<b>Model</b>	<b>Service Bulletin Description</b>	<b>Number</b>
All	Water softeners O-rings Tygon tubing Back flow prevention Contactors SSM water filter parts Serial Number Format Change Ice machine sanitation after a boil order Color and Model Series Change	PS-6-88 PS-9-88 PS-2-89 PS-9-92 PS-1-98 PS-8-98 PS-8-2004 PS-7-2005 PS-6-2006
AC125	Water inlet valve New leg parts	PS-1-89 PS-7-97
AF300	New oil seal New water shed New motor and motor housing	PS-12-2002 PS-15-2003 PS-1-2005
AFE325	New oil seal New water shed New motor and motor housing New compressor	PS-12-2002 PS-15-2003 PS-1-2005 PS-5-2005
AFE400	Drain and water system parts Bin thermostat bracket change TXV change New oil seal New water shed New motor and motor housing New compressor Added hi pressure cut out	PS-11-97 PS-4-2000 PS-13-01 PS-12-2002 PS-15-2003 PS-1-2005 PS-5-2005 PS-1-2006
Bins	Door frames Gasket color change BH260 and BH375 parts BH360 bin SB480 bin BH1100, BH1300, BH1600 bin Ice Express Service Parts Ice Express Cart Service Parts BH801 Service Parts BH1100, 1300, 1600 changes	PS-2-2000 PS-4-2000 PS-14-2000 PS-8-2002 PS-4-2003 PS-6-2003 PS-2-2004 PS-3-2004 PS-10-2004 PS-5-2006

# SERVICE BULLETIN

## **SUB

**CHANGES TO CHUTE - ASSEMBLED**

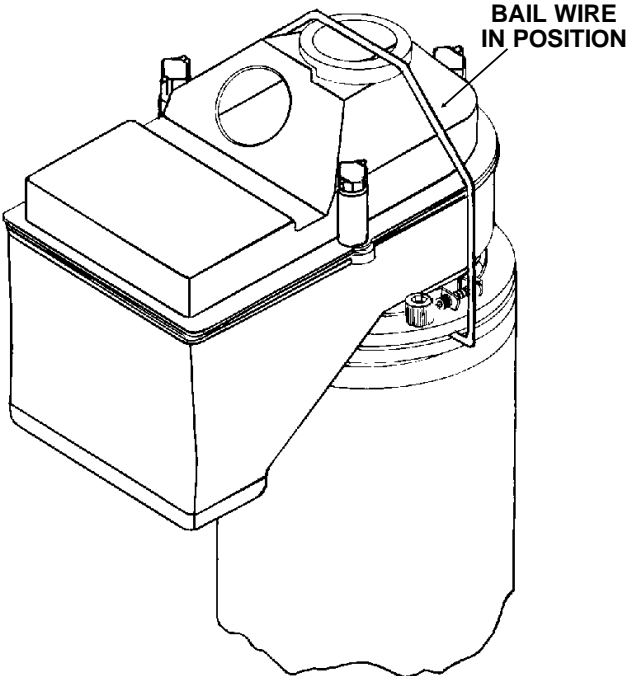
Beginning with January 1991 production, a clamp was added to the above models to help secure the ice chute assembly to the breaker. This required a change to the breaker; a groove was machined into the bottom of the breaker, and it is that groove that the clamp hooks into. This clamp is not retrofitable to prior ice machines. Service breakers at this time do not have the groove. The part number of the breaker and cover did not change.

The breaker cover has been changed from a stainless steel part that required a tool to remove, to a plastic part that can be removed by hand. Threads are still left-hand.

## SUBJECT: Sonar Ice Level Control Change

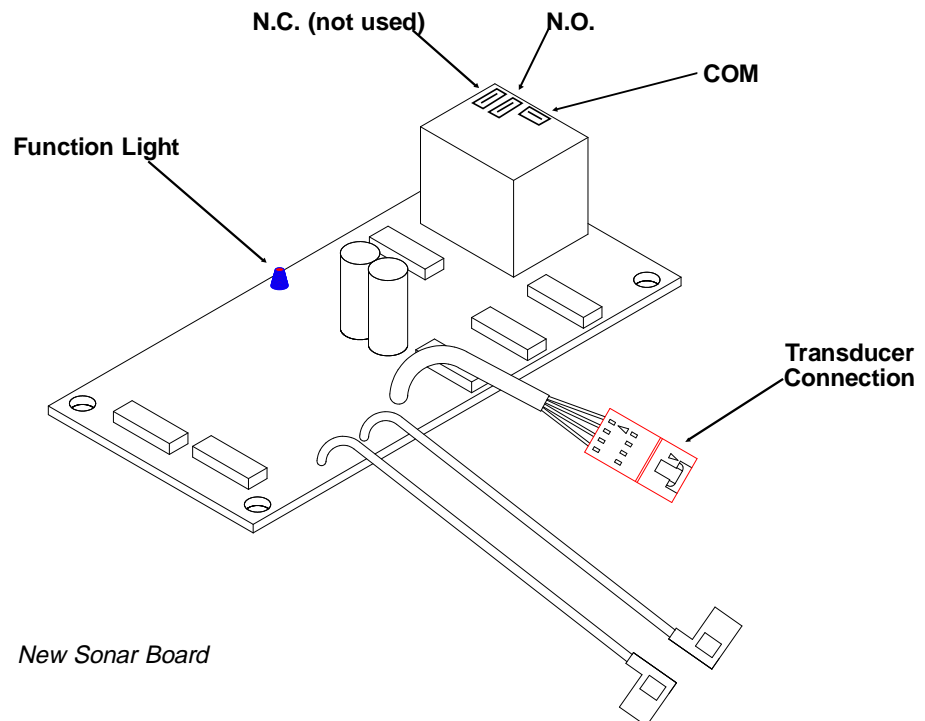
A change has been made to the sonar ice level control, beginning with with CMS and MCM machines manufactured after April, 1993 (date code -10L and higher).

The Sonar Board has had a function light added to indicate the status of the signal to the transducer and up to the relay on the sonar board. If this light is ON:

The transducer has also been changed. An additional circuit has been added, connecting low voltage power to an internal resistor (a small heater). The new sonar board has a connection for the new transducer. An adapter cord is required to use the new transducer with the older boards, and is included with the transducer kit described below.

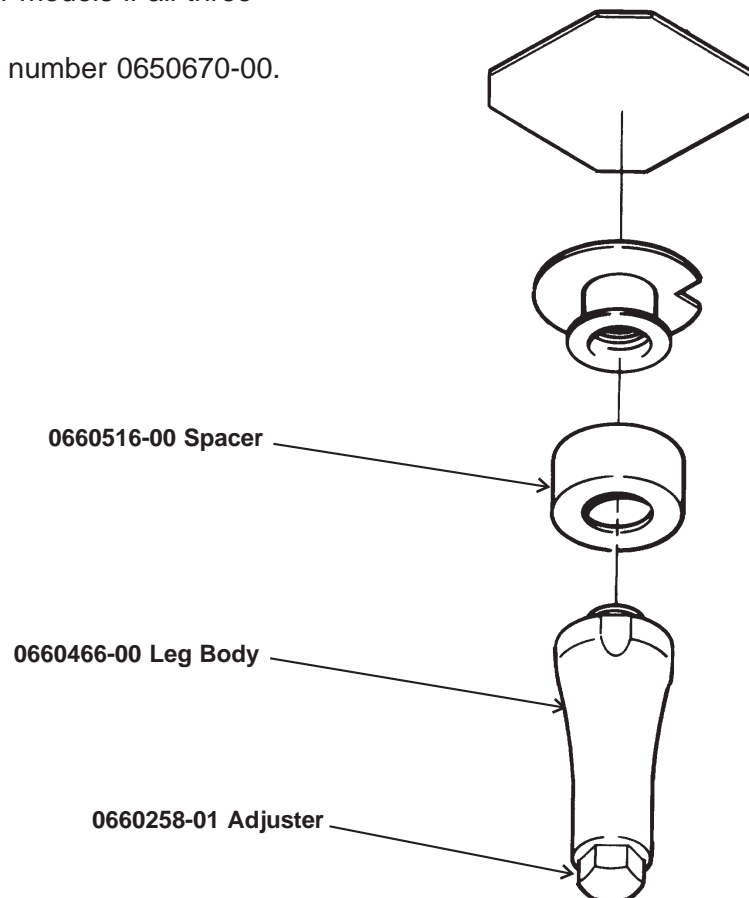
The design of the legs for these models has changed. CS60s now ship with these legs. These new legs fit the prior models if all three parts are used.

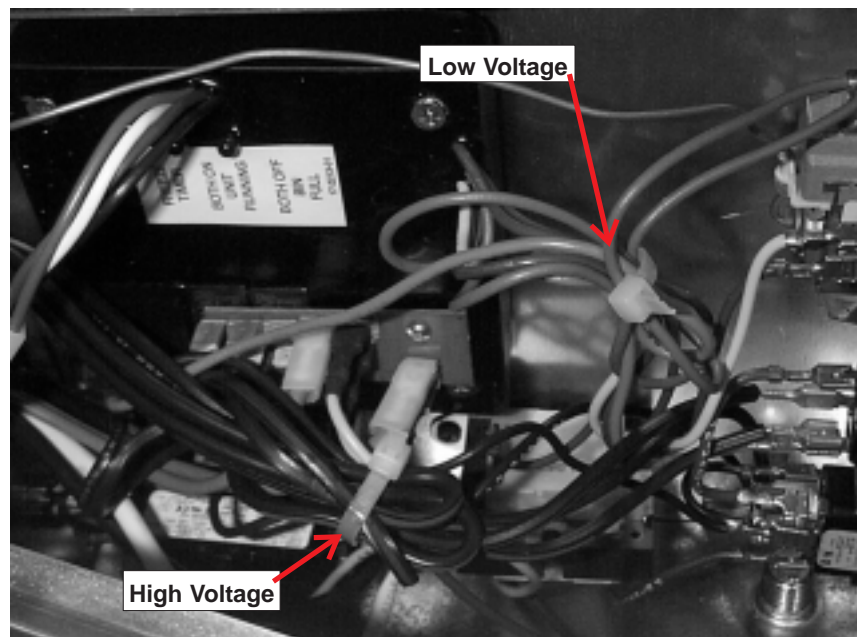
**Prior Layout**  
Wires are bundled together

**New Layout**  
Module is rotated and wires are separated into high and low voltage bundles.  
This can be done in the field by cutting the cable ties, removing the four module mounting screws and rotating the module 90° counter-clockwise. Then remounted with the original screws. The wires should then be bundled as shown.

## Subject: Insulation Change

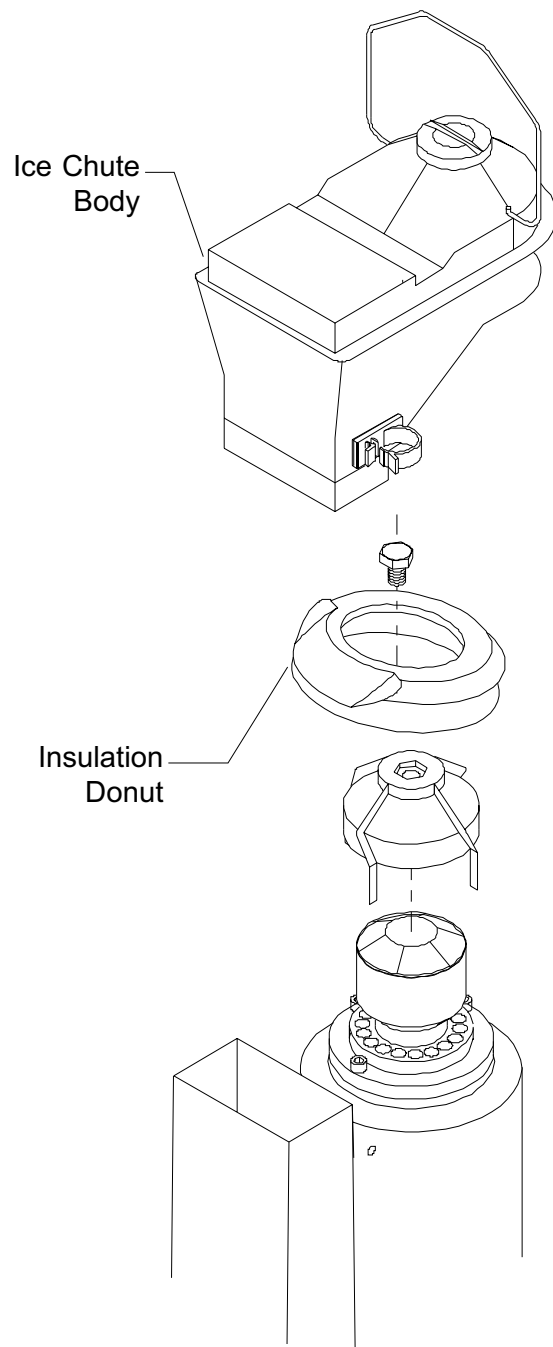
An insulation collar has been added to the space between the lower chute and the top of the evaporator. There is one collar (it looks like a big donut) for FME models and a different one for the nugget machines. The donut replaces the styrofoam insulation inside collar (pn A33102-001)

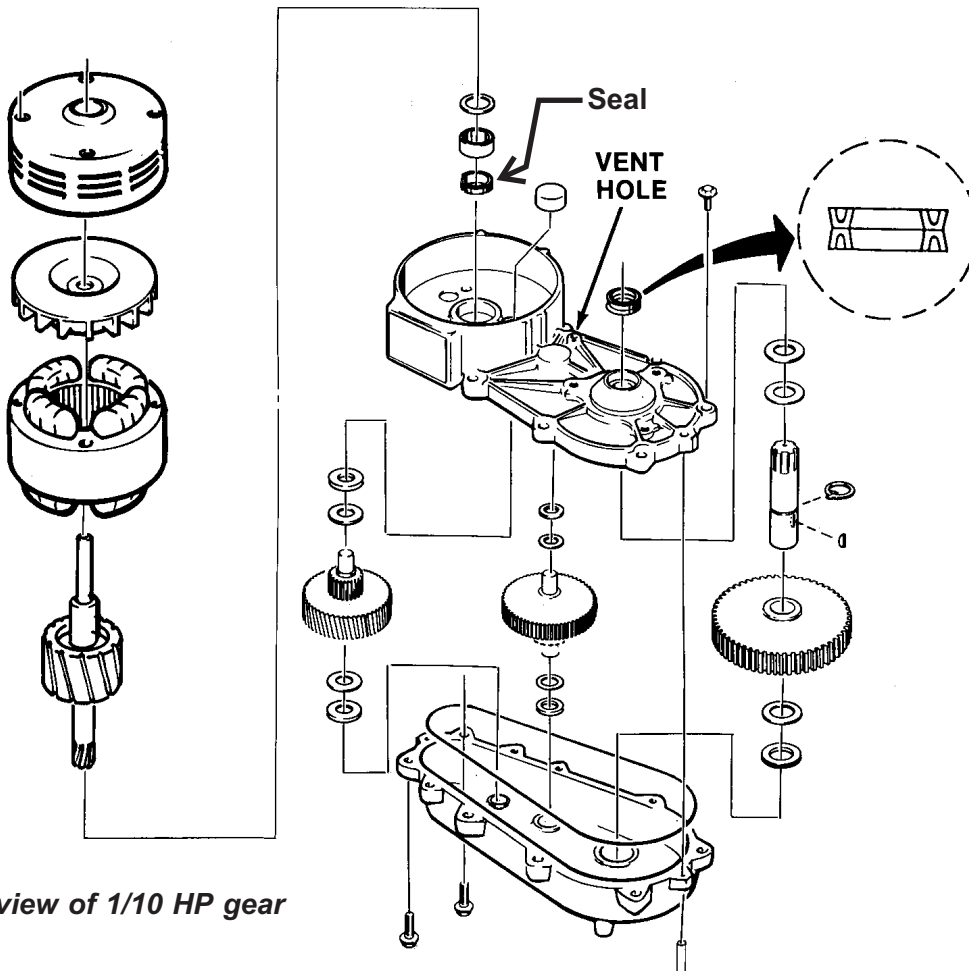
The input shaft oil seal has been changed **from two** 02-1504-00 seals back to back to **one 02-3969-20** seal.

When replacing the input shaft seals, remove **BOTH** input seals and install the new seal with the U-Cup facing the oil.

## **Subject: CSW45 evaporator and thermistor change to C series**

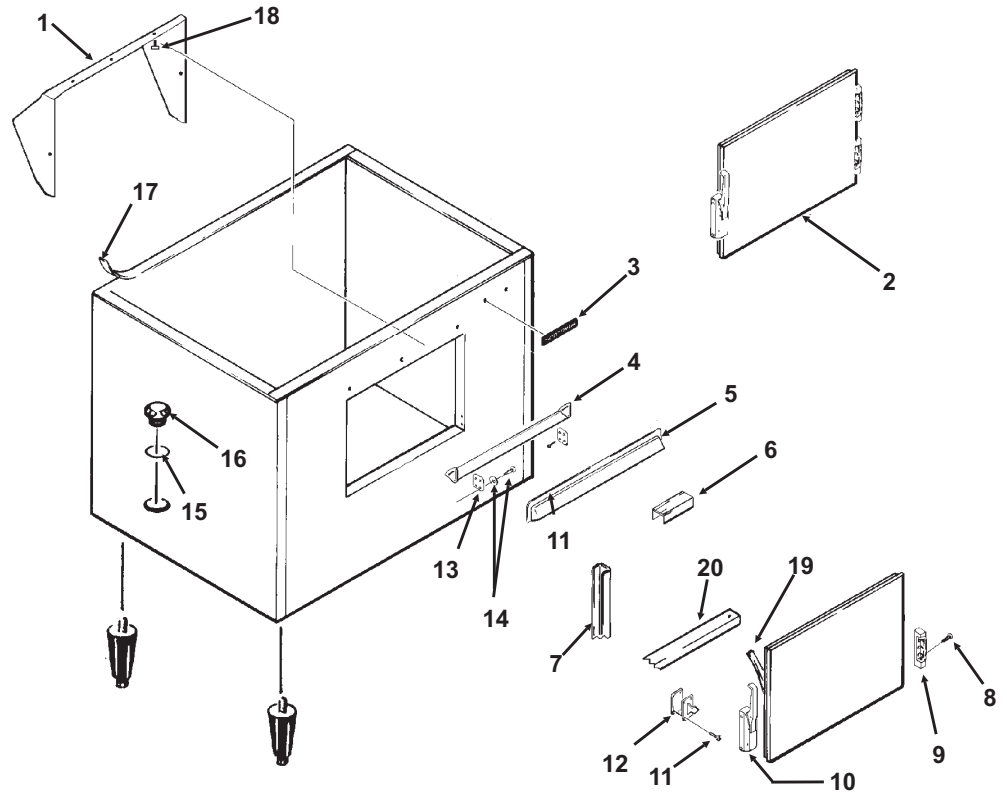
The evaporator in the CSW45 has been changed. Beginning with C series units, (CSW45-1C), the suction line diameter has increased. This required a change to the thermistor that mounts to the suction line.

Replacement evaporators will now come as a kit with the matching thermistor so they will fit any CSW45.

Replacement thermistors will now come as a kit with both large and small thermistors so they will fit any CSW45.

## Subject: Wiring Diagram Change, FME2404R and NME1854R

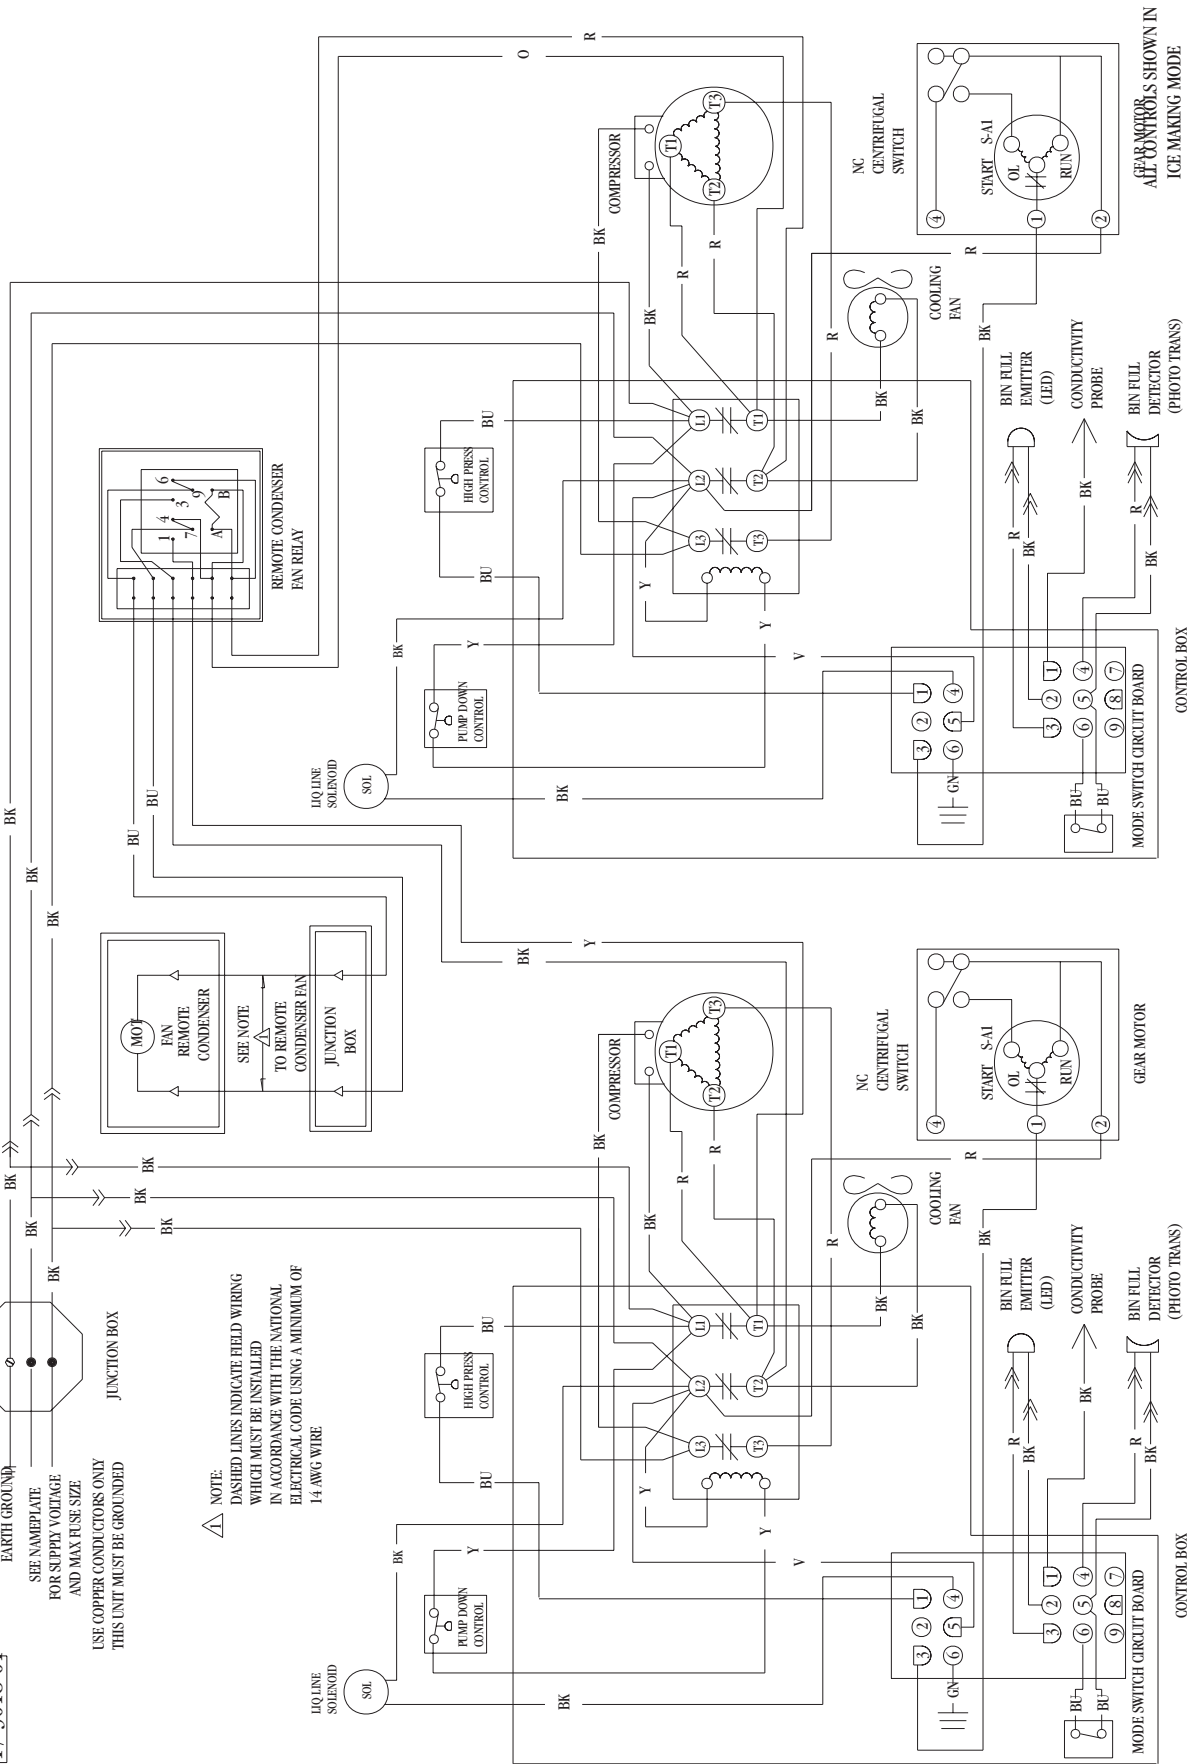
The wiring diagram for these models has been changed to correct an error. The original diagram wiring resulted in a mis-phased fan relay, which caused early life failure of the relay contacts. The single phase diagram is shown here, the three phase diagram is on the back of this bulletin.

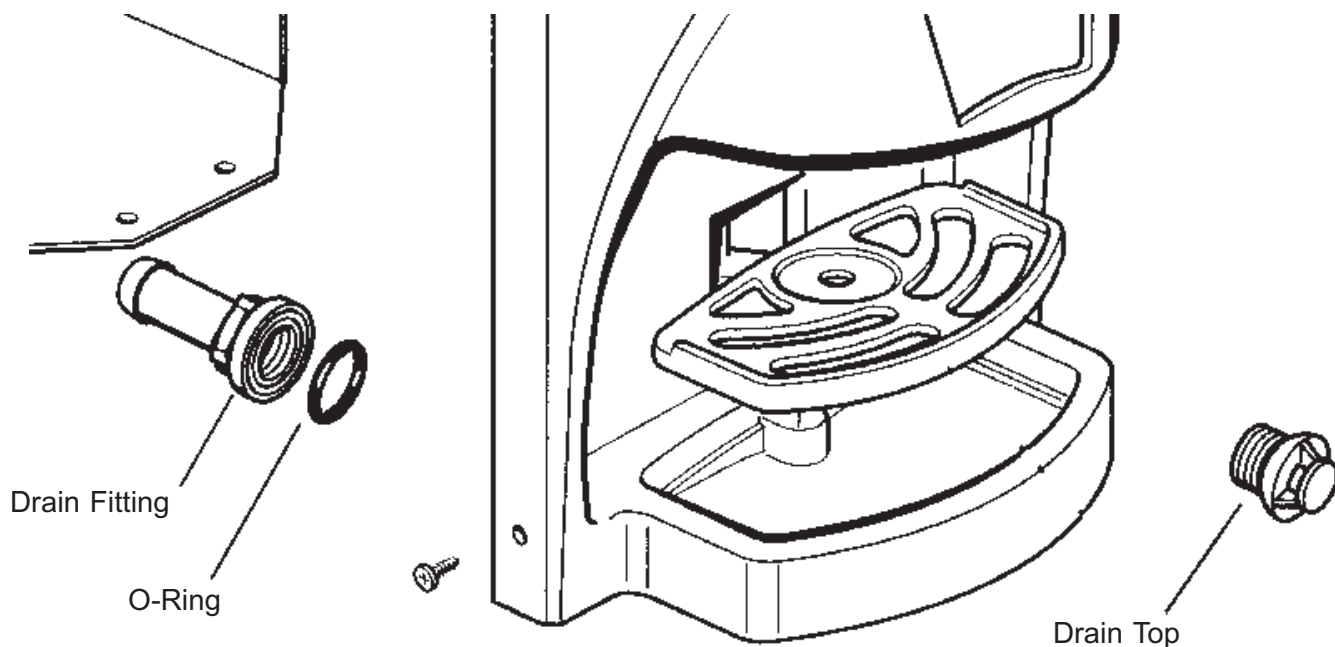
Beginning with serial number 707393-04S, the drain portion of the front panel has been changed. The prior drain was a PVC tube glued to the front panel. The new design uses a screwed together assembly, as shown in the exploded diagram below.

**Note:** To remove a front panel on the new design, the drain top must be removed so the panel can be separated from the drain fitting.
